Service Bulletin: SB407-3526; Bell 407 Air Conditioner Drive Pulley Bevel Washer Replacement.

Subject: Tail Rotor Driveshaft Bevel Washer Replacement.

Date: 15 Sept 2006
14 Jan 2007 Rev A
09 Feb 2007 Rev B

Applicability: Bell Helicopter Model 407 series equipped with the Air Comm Corporation air conditioner system.

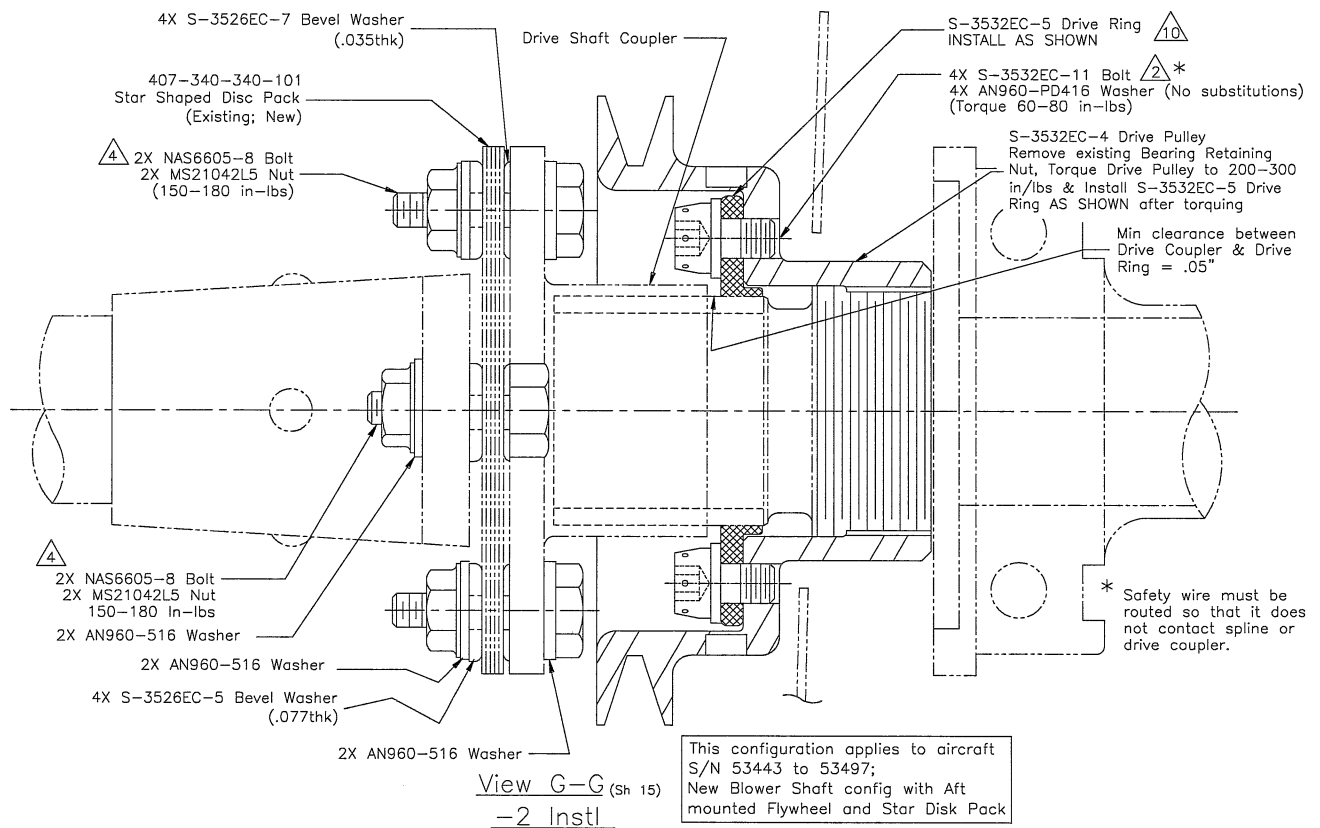
The recommended standard torque range is given in the following drawings.

***Tare "Drag" Torque shall be added to the torque value listed unless otherwise stated.**

Installation Configuration -2 (Installation of S-3526EC-7 Bevel Washers)

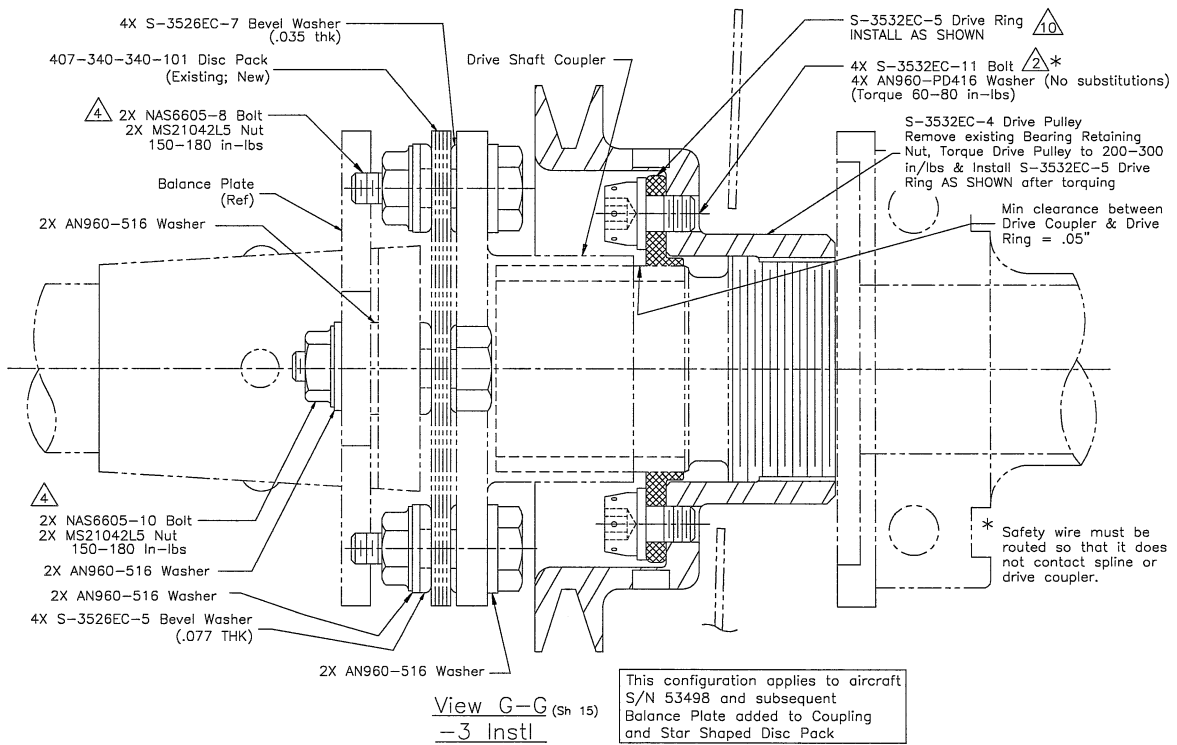
Rev A: S-3526EC-7 replaces the S-3526EC-4 or -6

Rev B: AN960-516 shown under nut on tail rotor drive shaft flange

3. Install the hardware shown in section VI. Bill of Materials, **Parts to be Installed** according to the configuration which is appropriate for your aircraft (-2, or -3). Inspect the other components to be reused for satisfactory condition and reinstall if found satisfactory. Replace unsatisfactory components.

4. Torque all fasteners in accordance with the specific Applied torques shown on the face of the illustrations for the appropriate configuration (-2, or -3).

Configuration	Part Number	Description	Quantity
-2	S-3526EC-7	Bevel Washer	4
	NAS6605-8	Bolt	2
	MS21042L5	Nut	4
*	*	*	*
-3	S-3526EC-7	Bevel Washer	4
	NAS6605-10	Bolt	2
	MS21042L5	Nut	4
